# North London Reinforcement Project

Application for Non-Material Change to National Grid (North London Reinforcement Project) Order 2014 (SI1052)

Document Reference: 101786-001  
Supporting Statement

Version: A  
May 2026

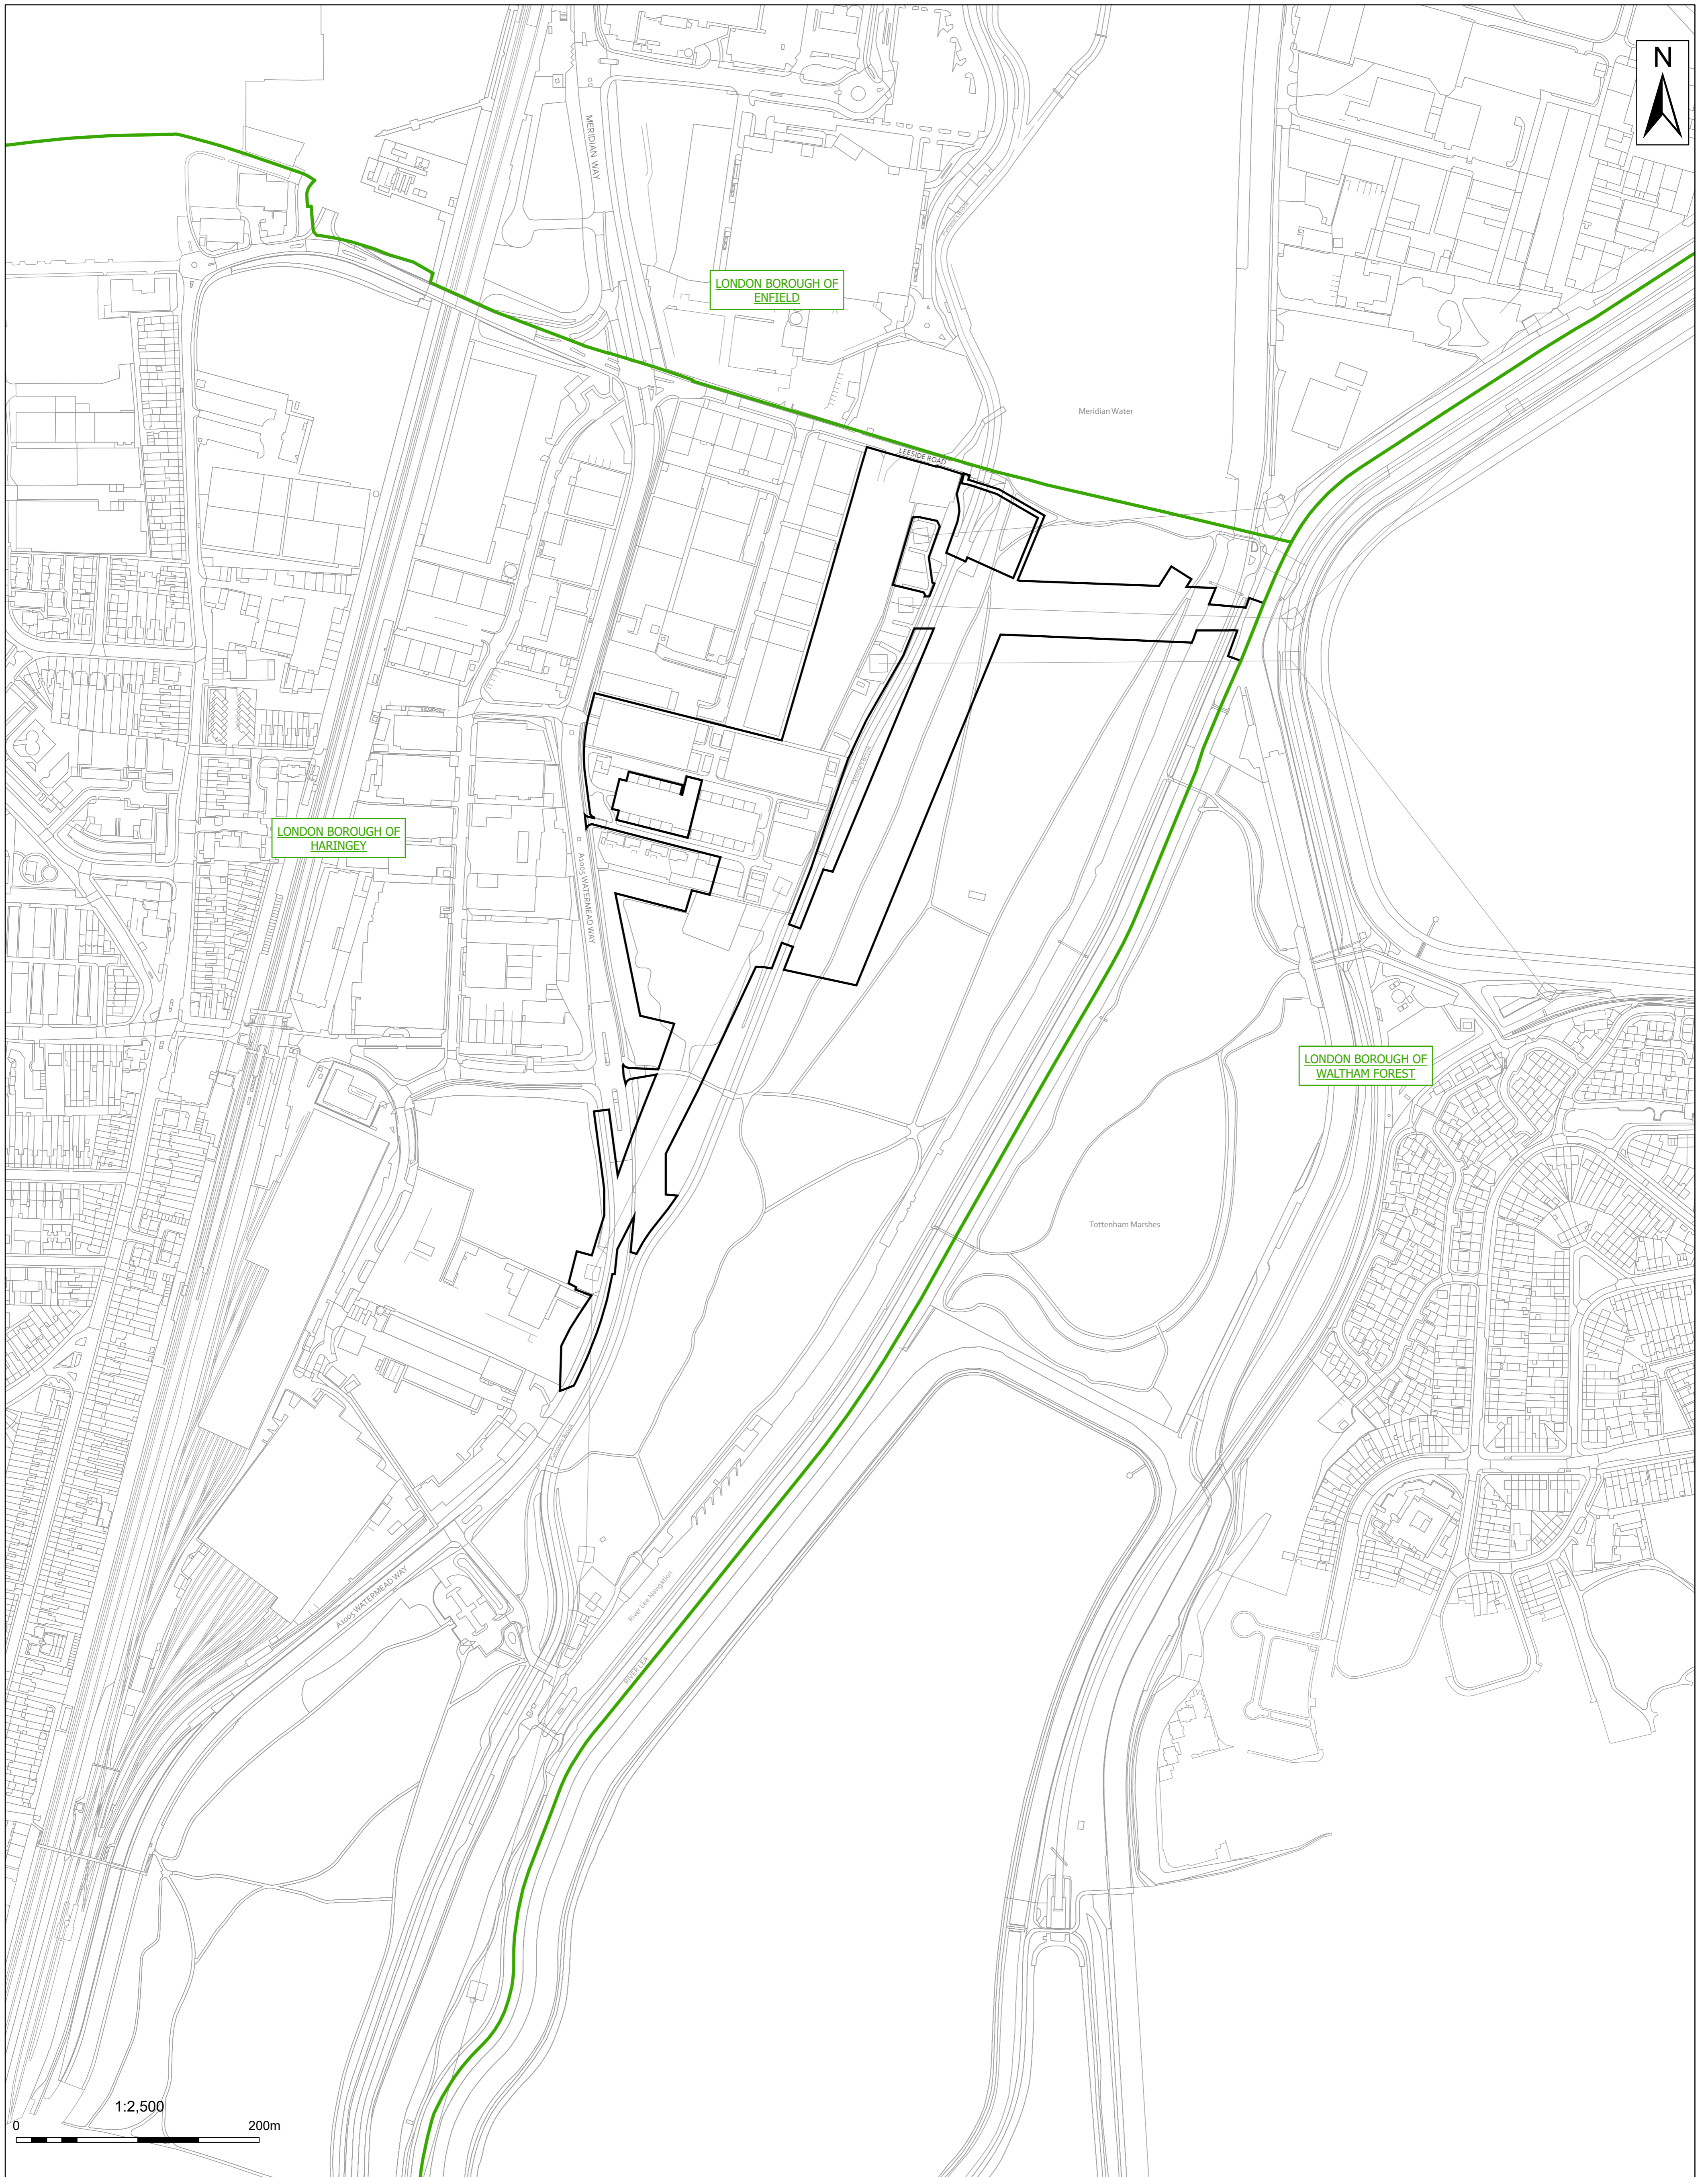
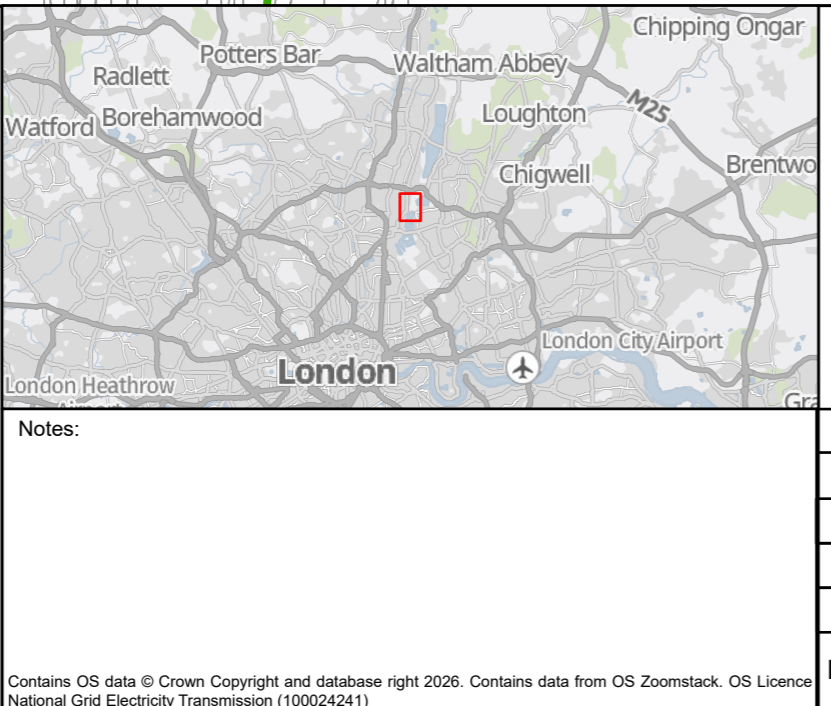
- 4.1.5 The Proposed Changes are located within the Proposed Non-Material Change Application Order Limits (hereafter referred to as the Site), see Amendment Order Limits Plan (ref: 30302490-ARC-EGN-ZZ-DR-ZZ-00003-S2) in Appendix A.

**Title:**  
North London Reinforcement Project – Proposed Non-Material Change Application – Concept Plan

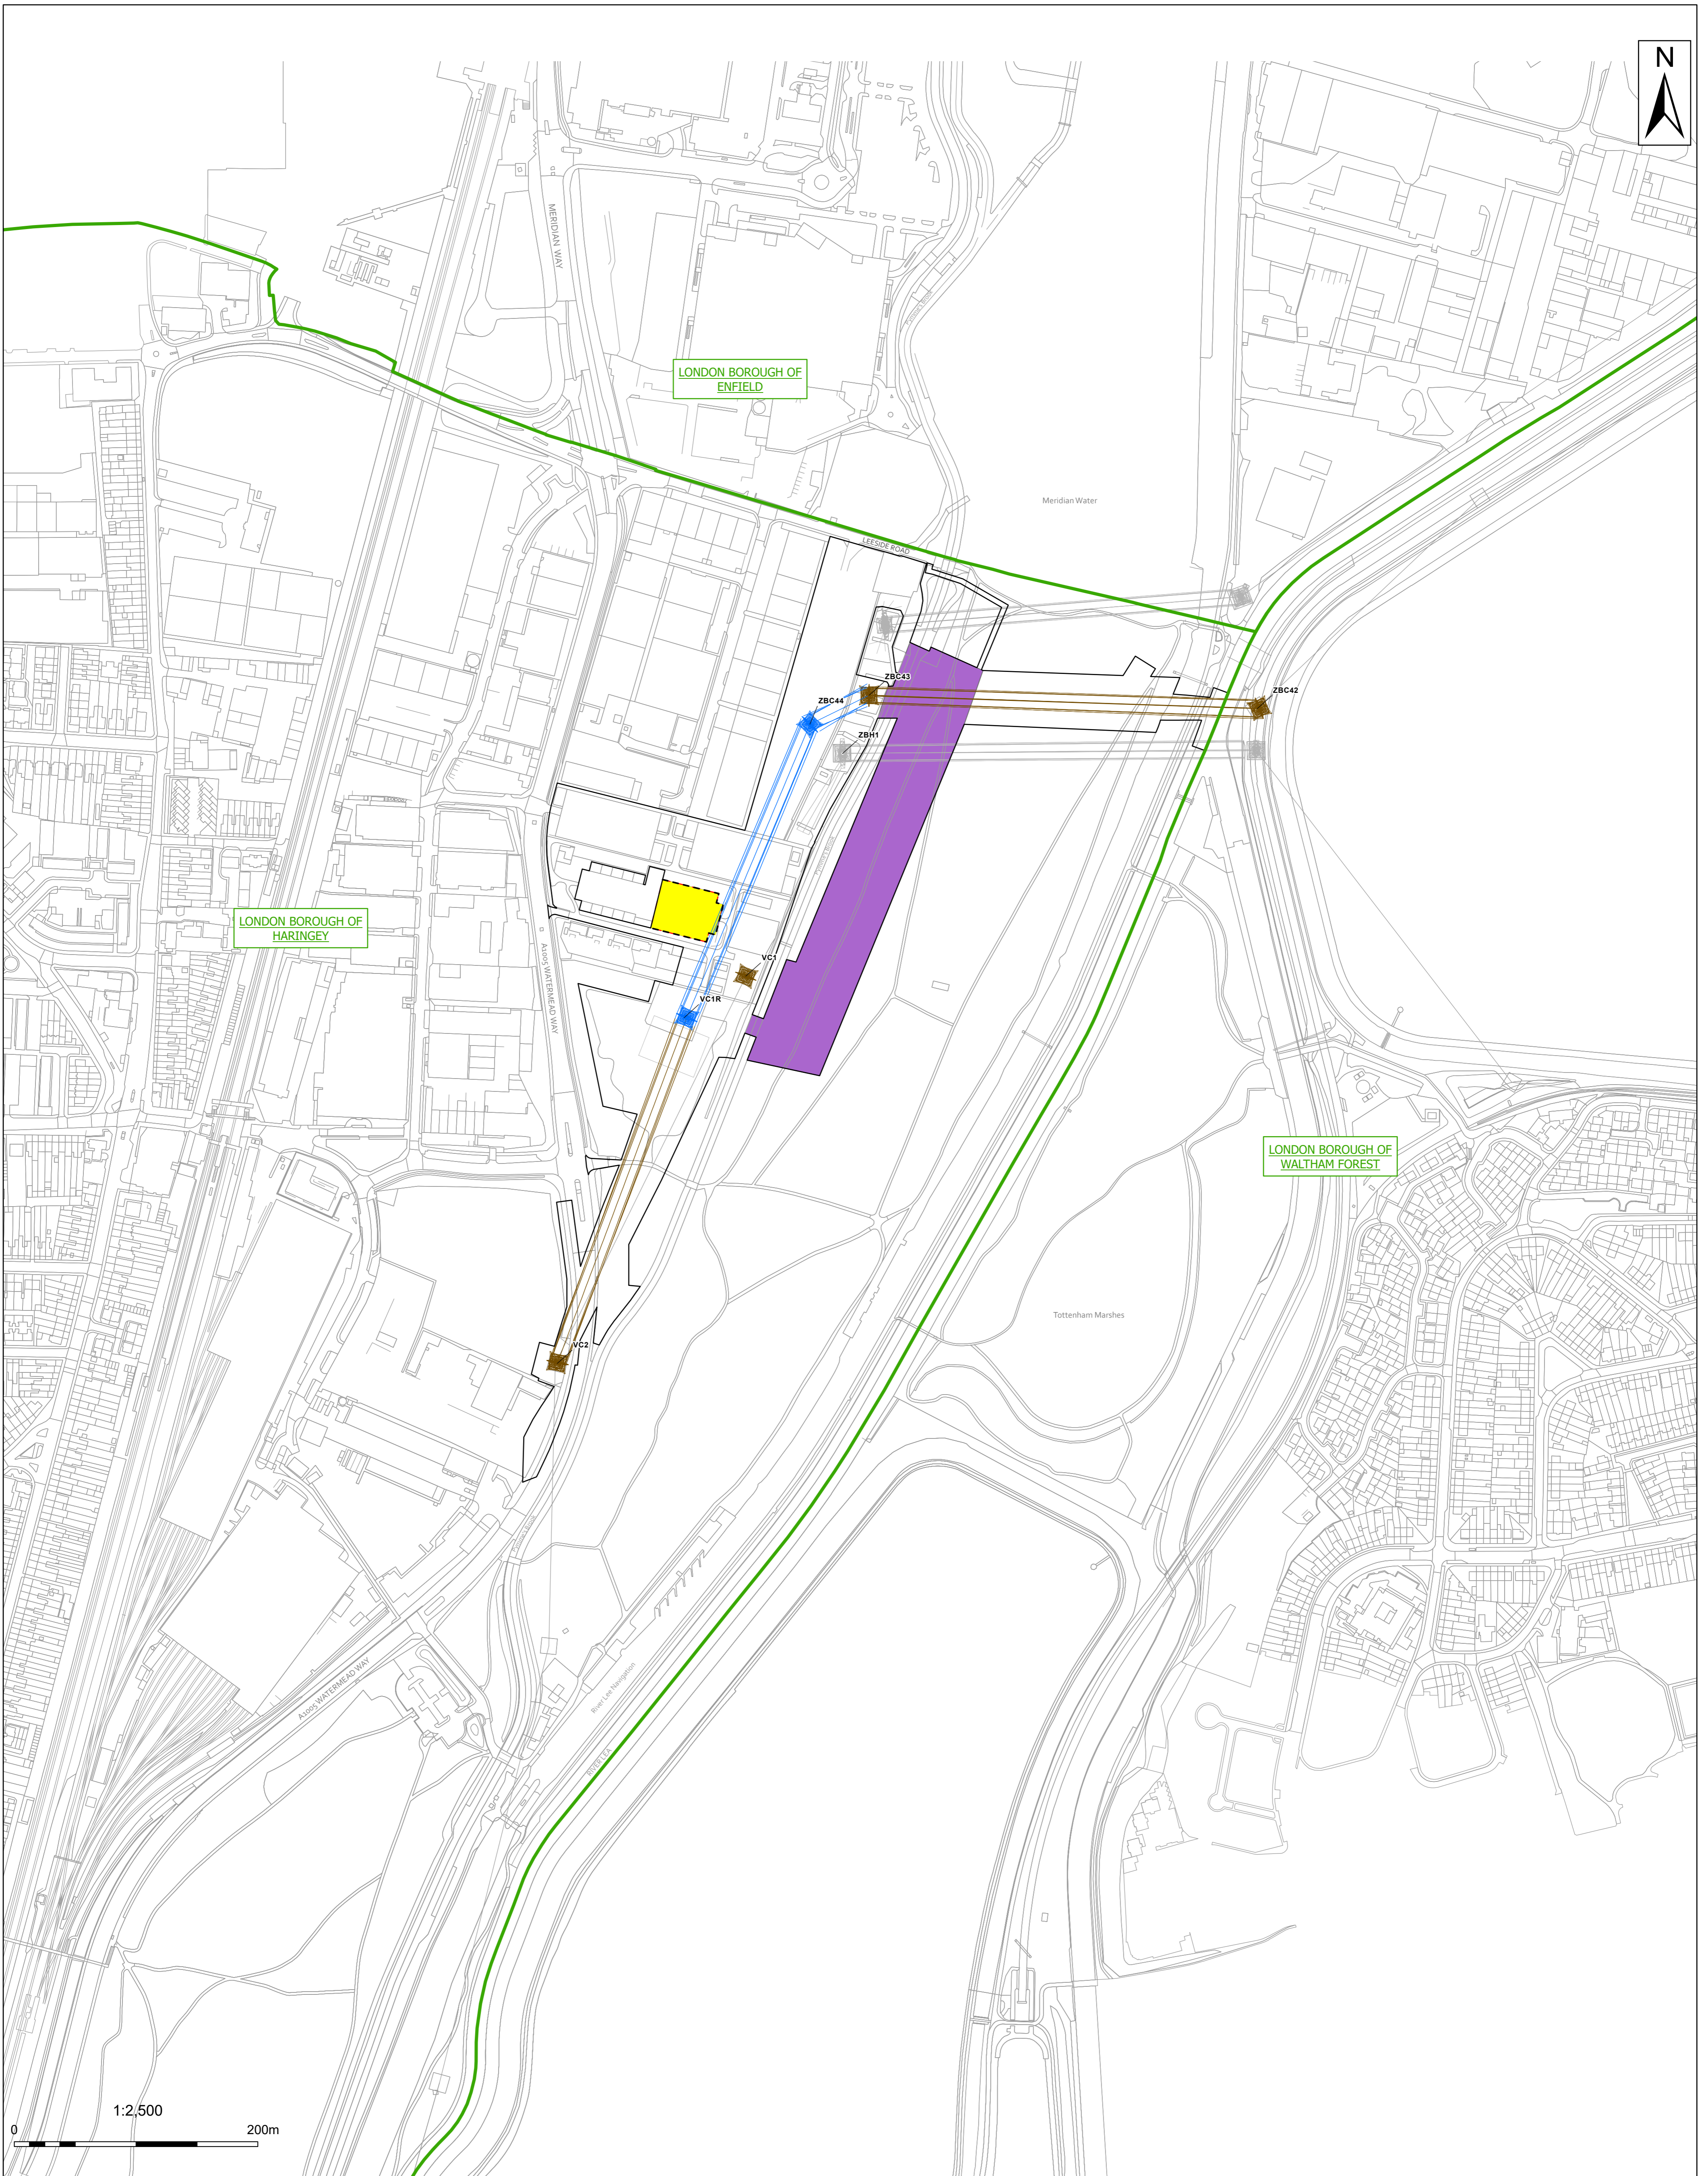
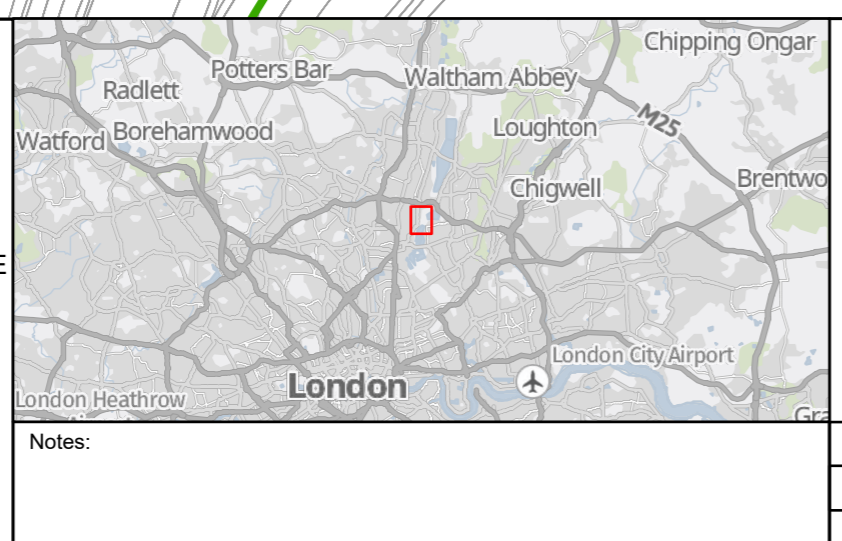
- 3.1.1 To facilitate an OHL bypass of Tottenham substation, NGET proposes to make five changes to the 2014 Order as set out below (the Proposed Changes). These Proposed Changes are shown in the Concept Plan (drawing reference 30302490-ARC-EGN-ZZ-DR-ZZ-00001-S2) in Appendix A.

- 3.1.2 To facilitate an OHL bypass of Tottenham Substation, transmission pylon VC1R consented under **Work No. 11** of the 2014 Order will need to be increased in height to allow sufficient safety clearances of the substation. The plans and sections certified under Article 43 of the 2014 Order show transmission pylon VC1R at a height of 46.3m (not including the 3m limit of deviation). Proposed Change 1 is to increase the height of transmission pylon VC1R to 62m (not including the 3m limits of deviation). This is an increase in height of 15.7m.

- 3.1.5 To facilitate an OHL bypass of Tottenham Substation, Proposed Change 2 relates to the installation of a new transmission pylon – ZBC44 - at a height of 61m (not including the 3m limits of deviation) within the Order Limits and on land owned by NGET.
- 3.1.6 This change requires amendments to the description of **Work No. 10** in Schedule 1 to the 2014 Order and to the relevant plans and design drawings certified under Article 43 of the 2014 Order.

- 3.1.7 To facilitate an OHL bypass of Tottenham Substation, Proposed Change 3 is for the installation of two short sections of new 400kV OHL comprising new phase and earthwire conductors, insulators and fittings to connect:

- 3.1.9 To facilitate an OHL bypass of Tottenham Substation, Proposed Change 4 would involve a minor extension to the 2014 Order Limits. The proposed new section of OHL between new transmission pylon VC1R and the new transmission pylon ZBC44 (Proposed Change 3) will span over the southeastern corner of the Tottenham substation building which lies to the north of transmission pylon VC1R.
- 3.1.10 Tottenham substation is owned by NGET and leased to a Distribution Network Operator (DNO). The Order Limits will be extended to include the part of the substation building over which the proposed new section of OHL will span.
- 3.1.11 This change requires the replacement and amendment of the relevant plans and design drawings certified under Article 43 of the 2014 Order.

- 3.1.12 As an OHL bypass of Tottenham substation is now proposed instead of an underground cable bypass, this change would amend Schedule 1 of the 2014 Order to remove from the authorised development any works relating to the underground cable bypass. Change 5 will omit the following authorised works under Work No. 10 relating to the underground bypass:
